Duquesne Light

Reference: Beaver Valley Power Station, Unit No. 1
Docket No. 50-334, License No. DPR-66
NUREG-0737, Item II.B.3; Post Accident Sampling System
Post Implementation Review

Post Accident Sampling System
Response to NRC letter dated June 30, 1982

Attachment A

Figure 1

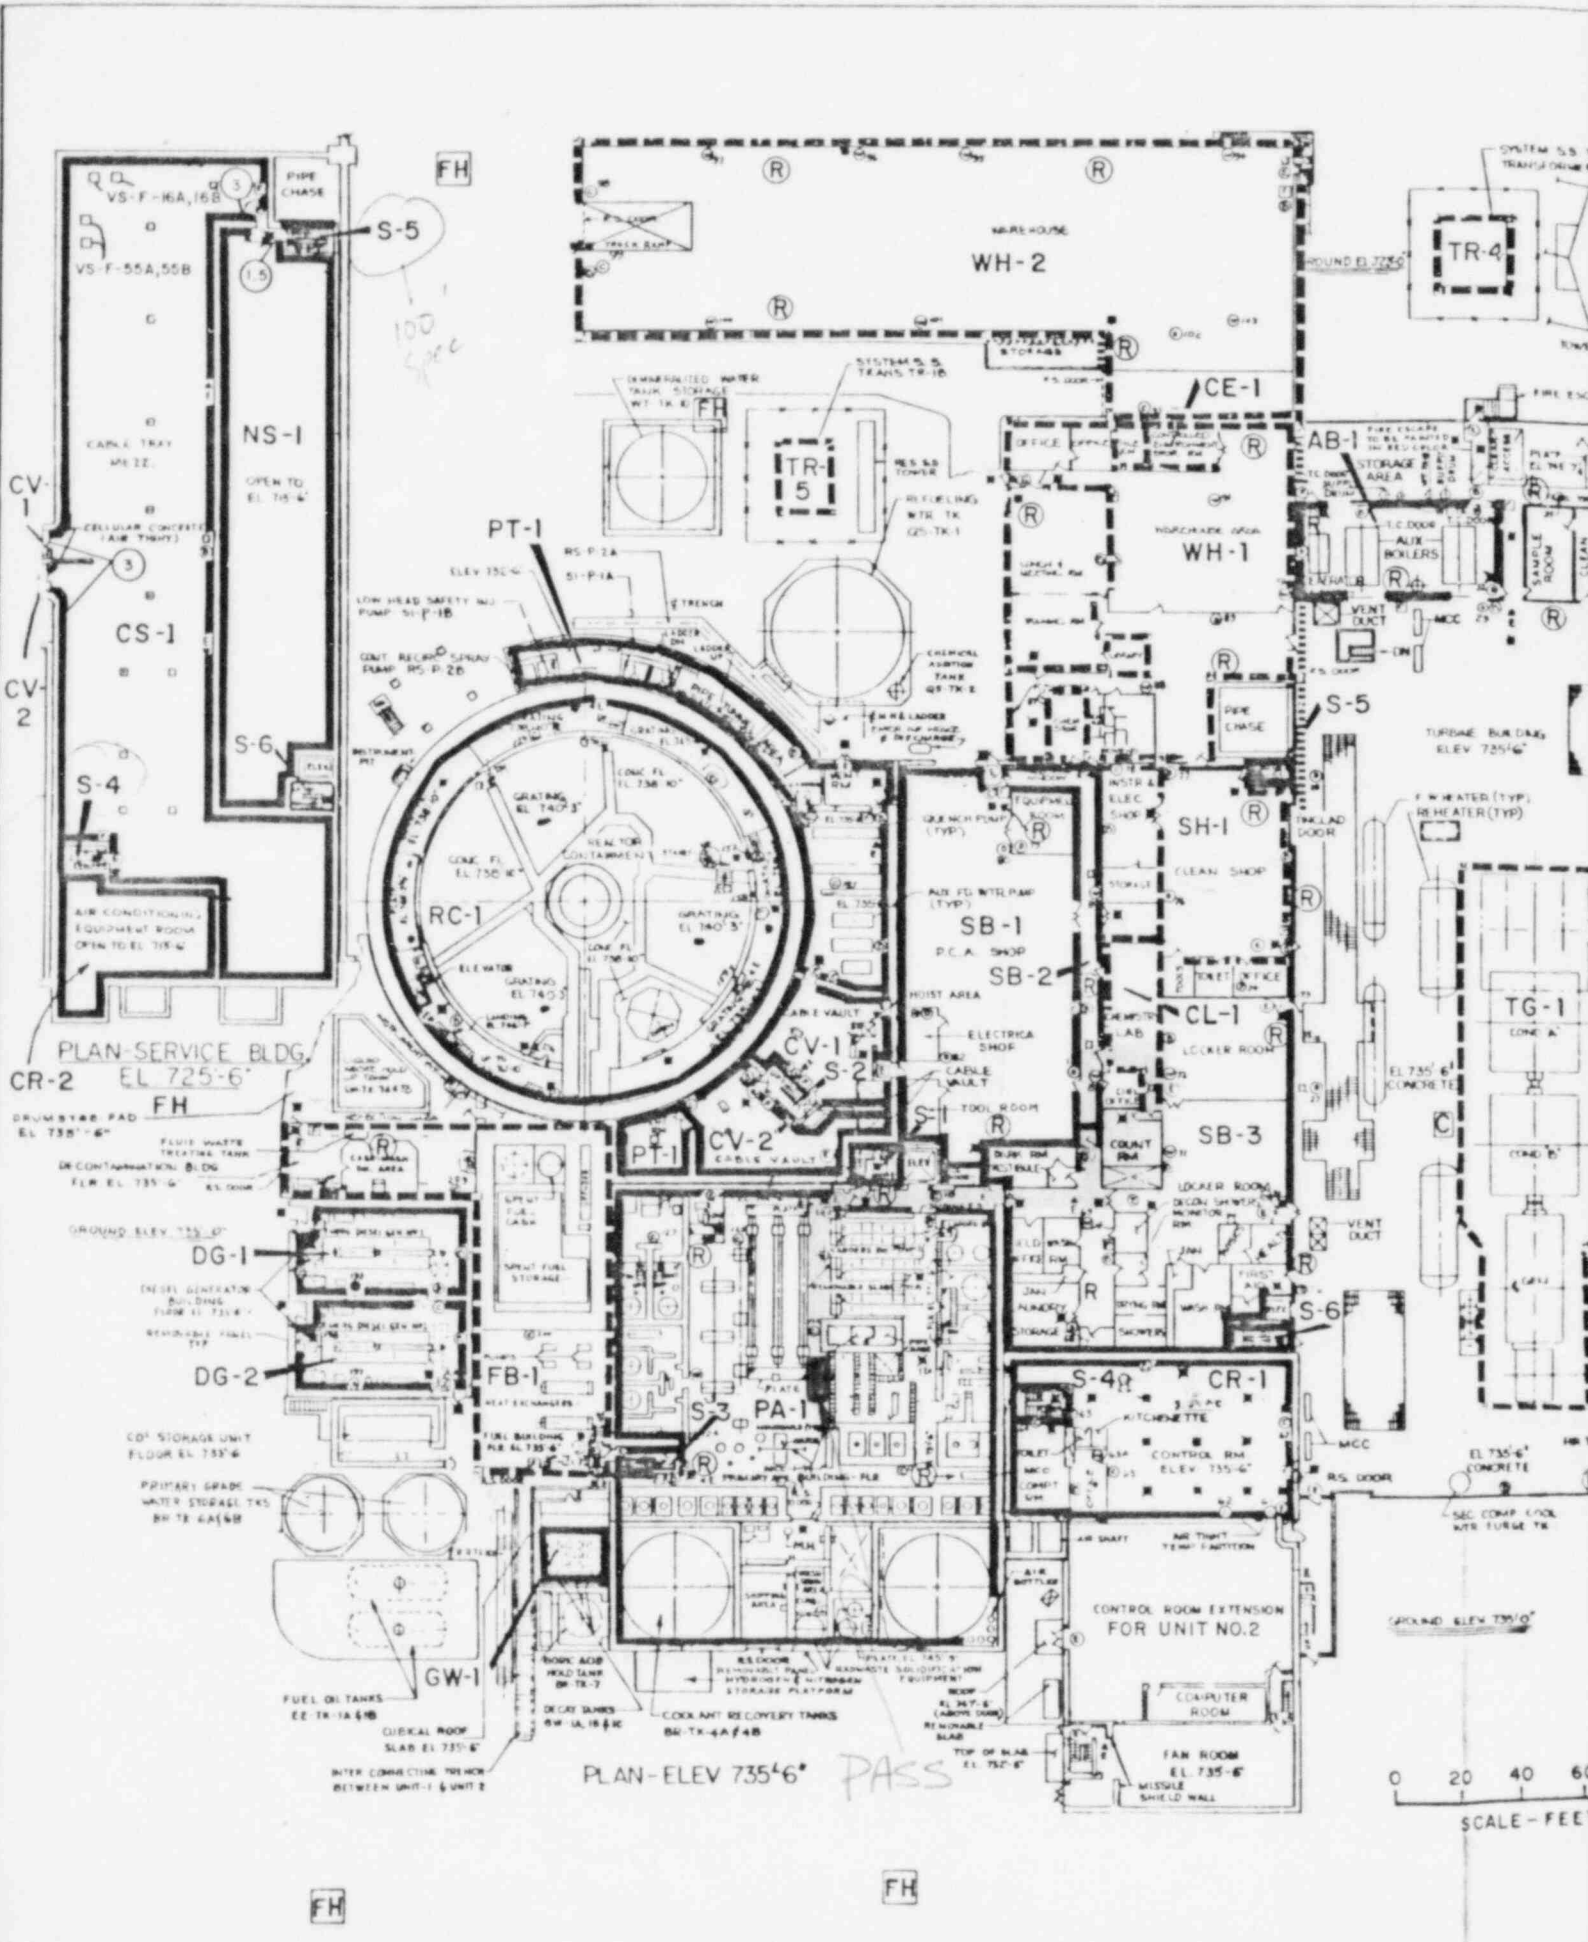
Provide information on sampling(s) and analytical laboratories locations including a discussion of relative elevations, distances and methods for sample transport. Responses to this item should also include a discussion of sample recirculation, sample handling and analytical times to demonstrate that the three-hour time limit will be met (see (6) below relative to radiation exposure). Also describe provisions for sampling during loss of off-site power (i.e. designate an alternative backup power source, not necessarily the vital (Class IE) bus, that can be energized in sufficient time to meet the three-hour sampling and analysis time limit).

The Post Accident Sampling System (PASS) is located on the same elevation as the chemistry hot laboratory and approximately 200 ft. away. Refer to Figure 1. After a sample has been collected, it will be transported by the PASS operator to the counting room along the path indicated on Figure 1. It has been determined that the radiation levels of a diluted sample are sufficiently low to permit handling of the sample utilizing established techniques.
